# Recommendation from impedance

B. Salvant

on behalf of BE-ABP/HSC section and impedance WG

# Longitudinal low frequency impedance

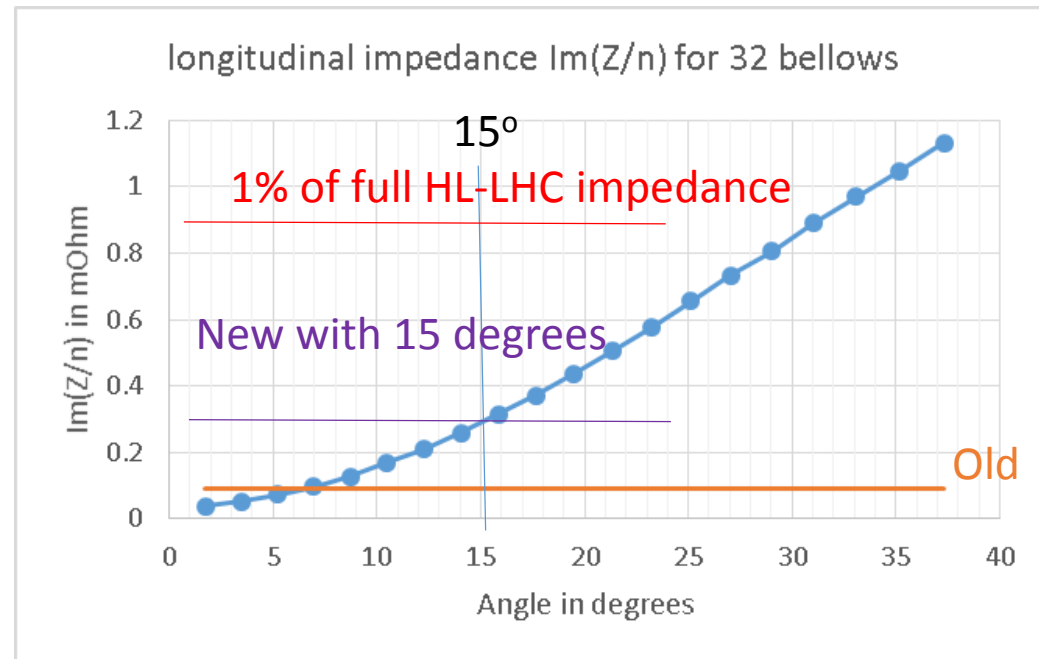
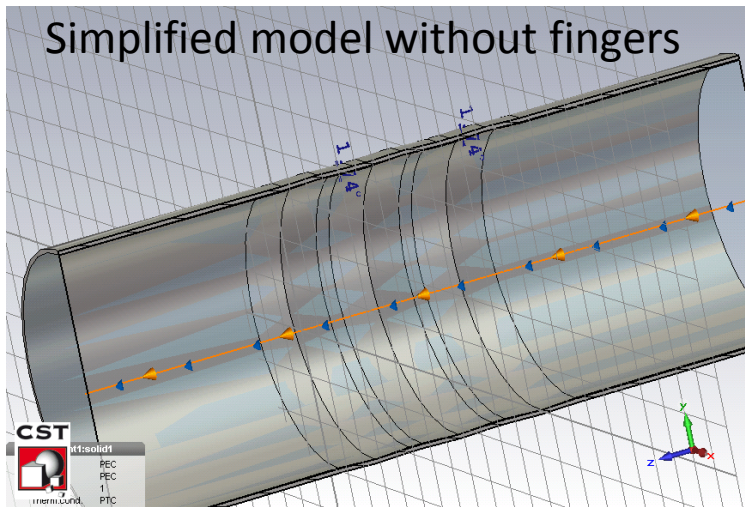
- Assuming 32 shieldings with 65 mm radius
- Large contribution compared to current shielding type (estimated a factor 3.5 increase)
- Would amount to 0.3% of total impedance
- Going to 30 degrees for all shieldings would reach 1% of full HL-LHC impedance

# Transverse low frequency impedance

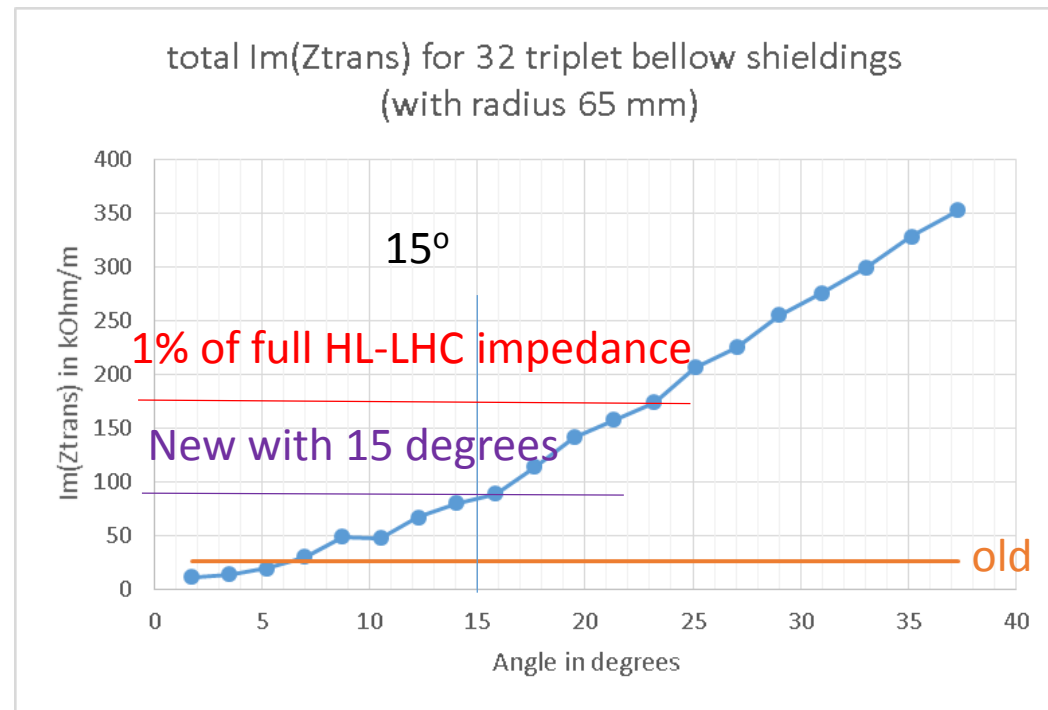
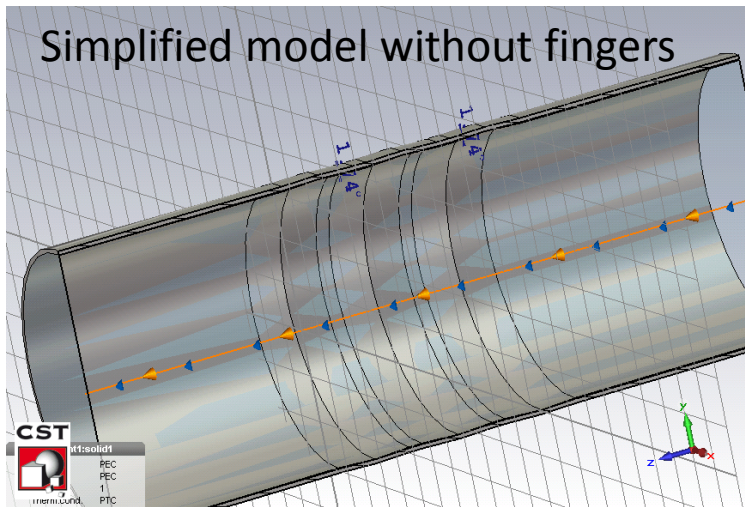
- Assuming 32 shieldings with 65 mm radius at 12 km beta function
- Large contribution compared to current shielding type (estimated a factor 3.5 increase)
- Would amount to 0.5% of the total LHC impedance
- Increase to 30 degrees reaches 1.5 % of the full HL-LHC impedance
- Risk to increase beyond 15 degrees, in fact we already said it should be reduced.<sup>7</sup>

# Impedance cost of bellows (formula of K. Ng)

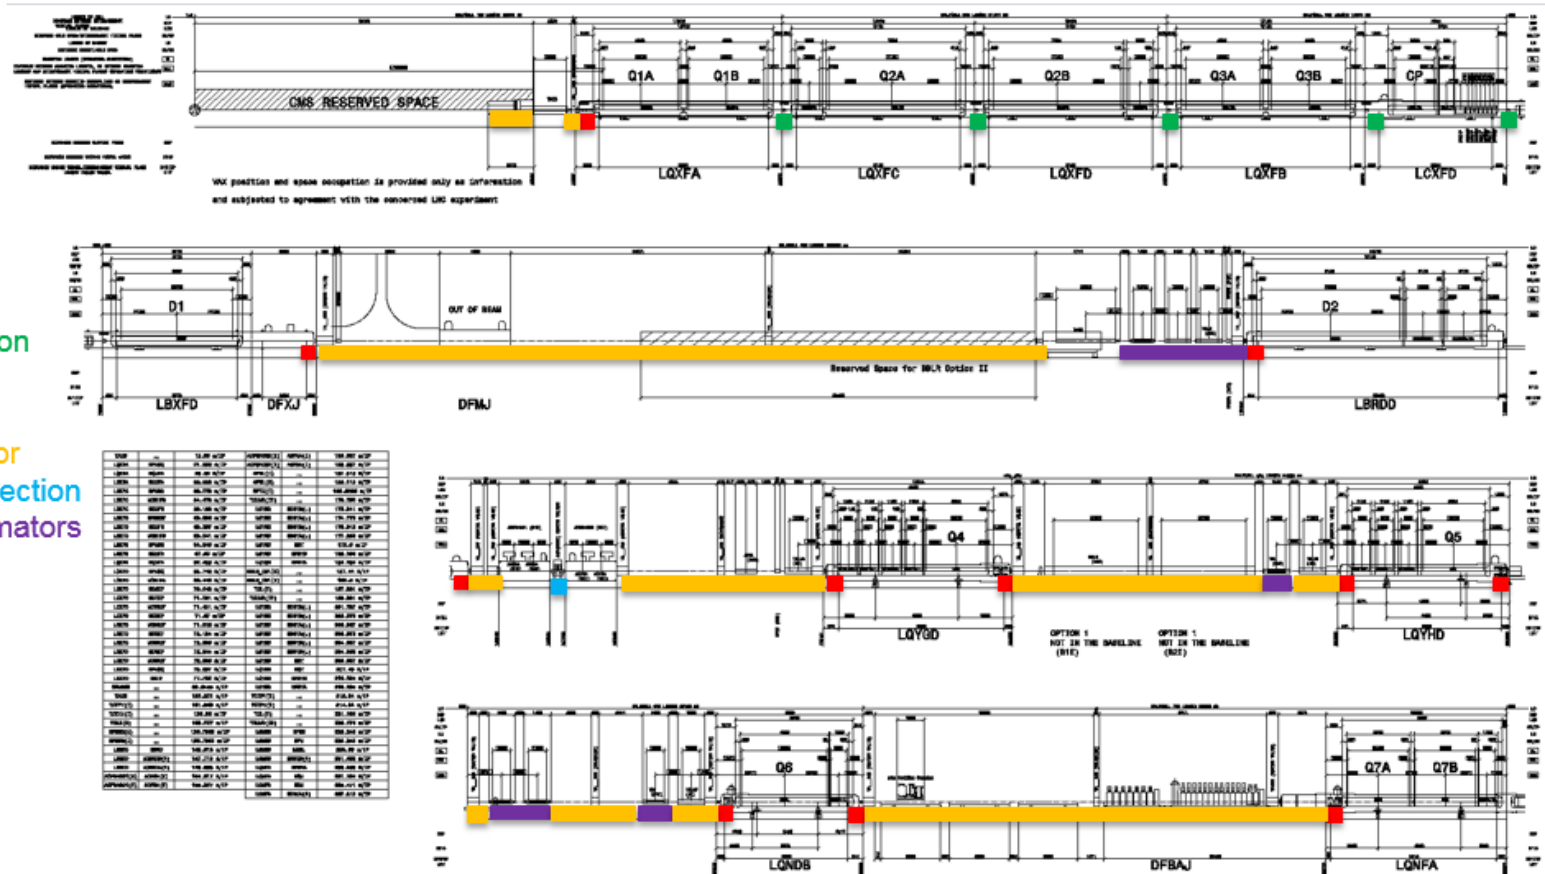
Why step in radius?  
Is that "only" for standard valve?

- Expensive in terms of impedance
- Management should decide

# Deformable fingers everywhere???

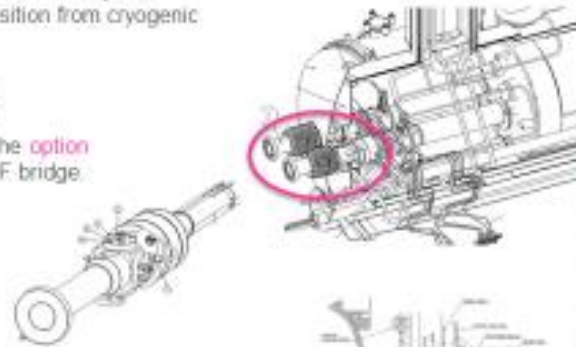
- Cold-warm transition are the connections for different temperature. They are located on both sides of each cryostat in order to do the transition from cryogenic to room temperature.
- Some interconnects have to house Beam-Position Monitors.
- The type of the vacuum module to be used is under study. The **option considered** are the new vacuum modules with deformable RF bridge.

Avoid cavity!

# Transverse impedance of beam screen in triplets (IR1&IR5) (2D calculation with ImpedanceWake 2D – N. Mounet)

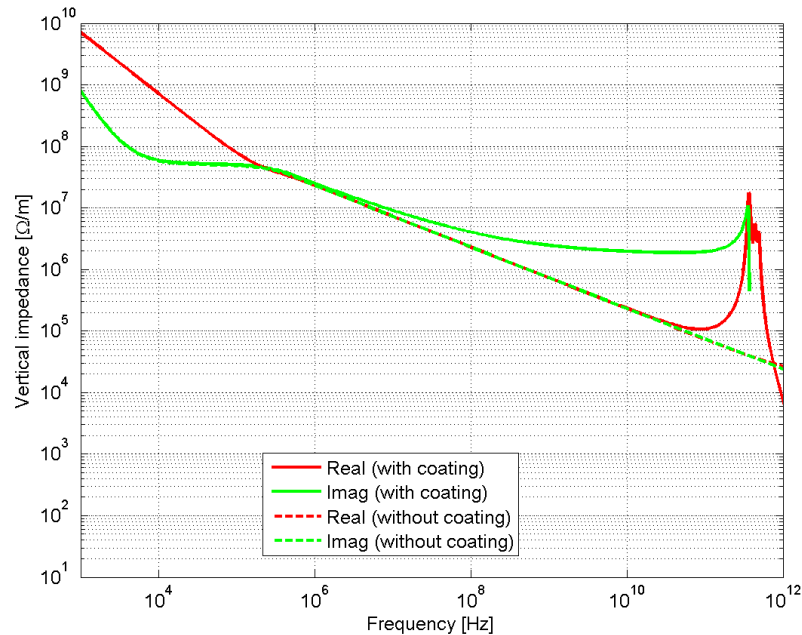
- Significant impact of coating on imaginary part
- Vertical effective impedance of the beam screen increased by 70% because of the coating.
- Still expected to be in the background of the total LHC impedance (~20 MOhm/m)

# New Y chamber

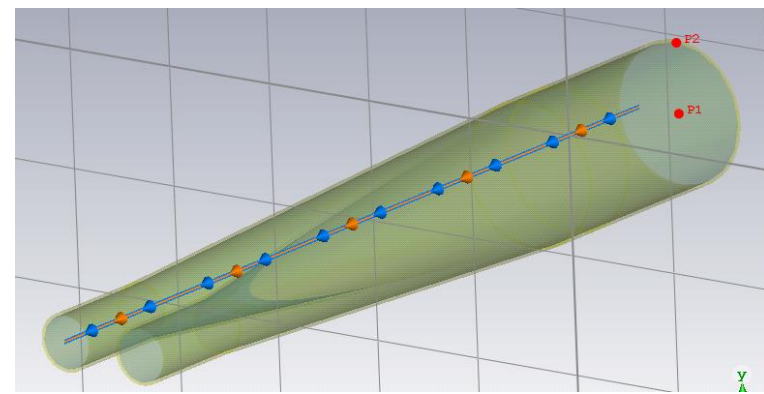
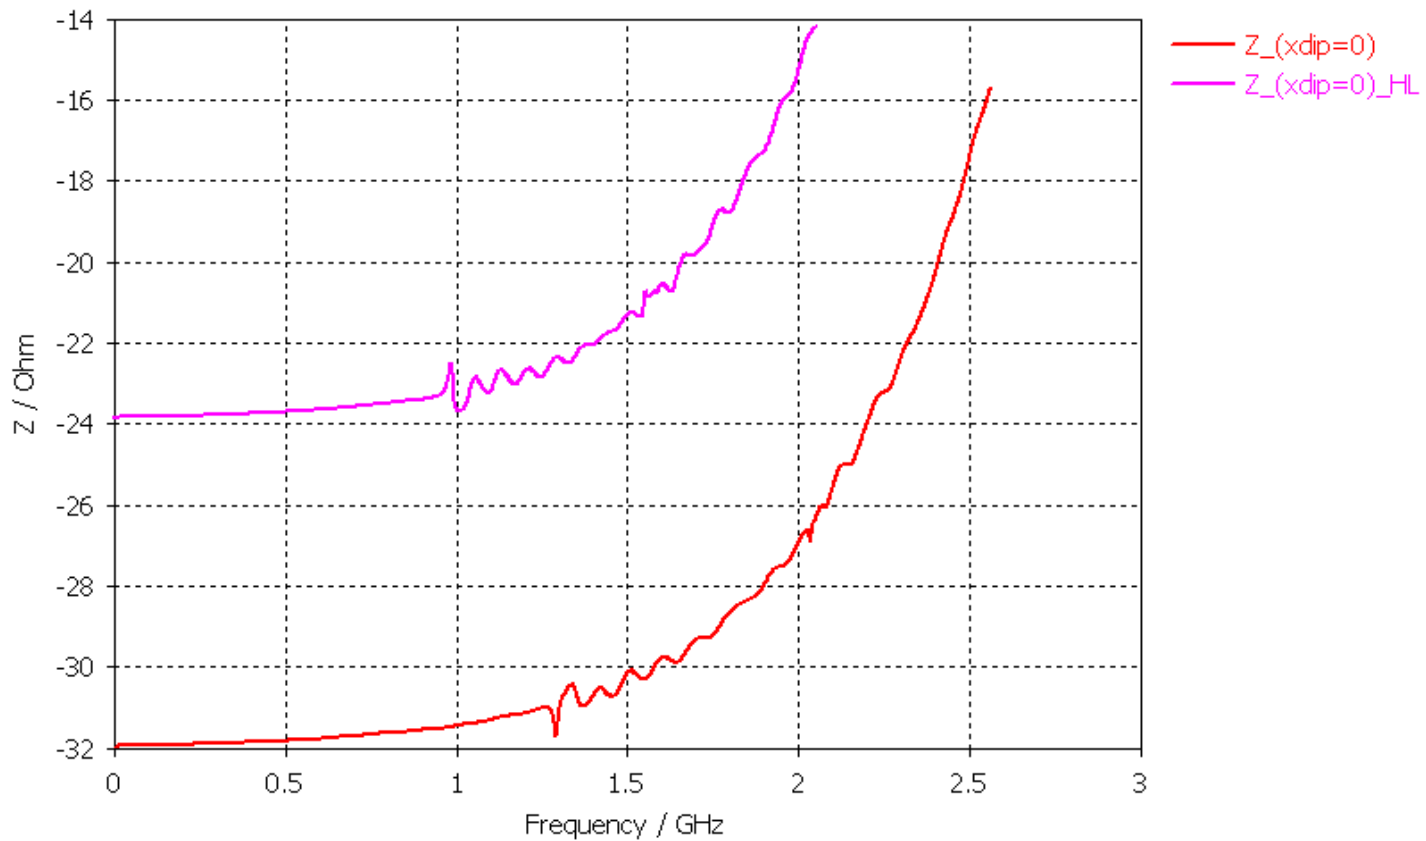
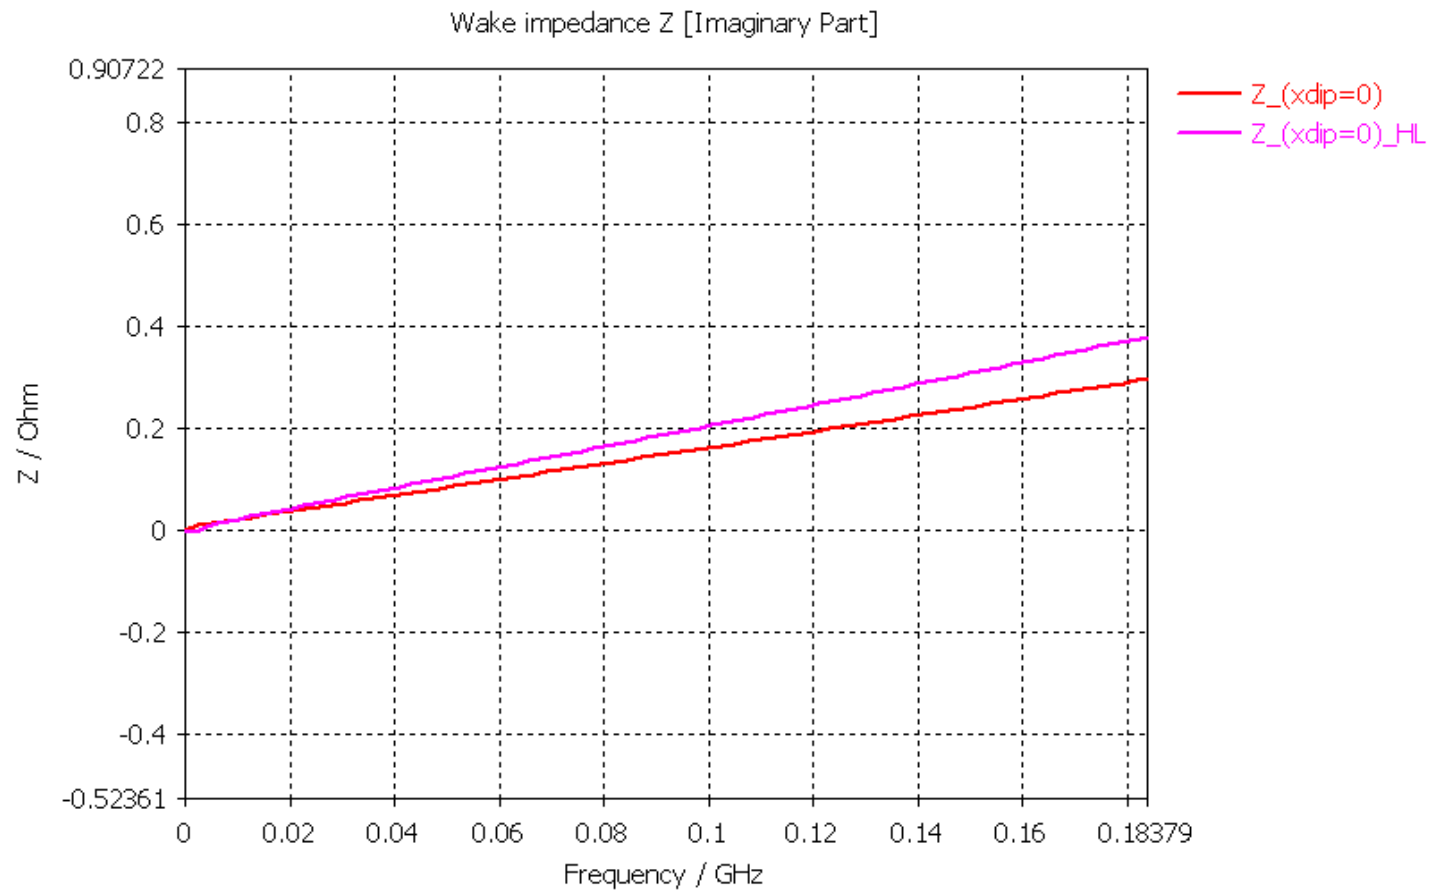
Larger diameters  $\rightarrow$  lower frequency for modes but also lower resistive wall

→ Lower frequencies and lower impact due to taper IN (and of course taper OUT – not shown).

→ No visible significant mode.

$\text{Im}(Z_{\text{eff\_long}}/n)$  slightly higher (0.03 instead of 0.02 mOhm)  $\rightarrow$  still negligible

- Geometry of the Y chamber already well optimized
- No significant mode or effective contribution
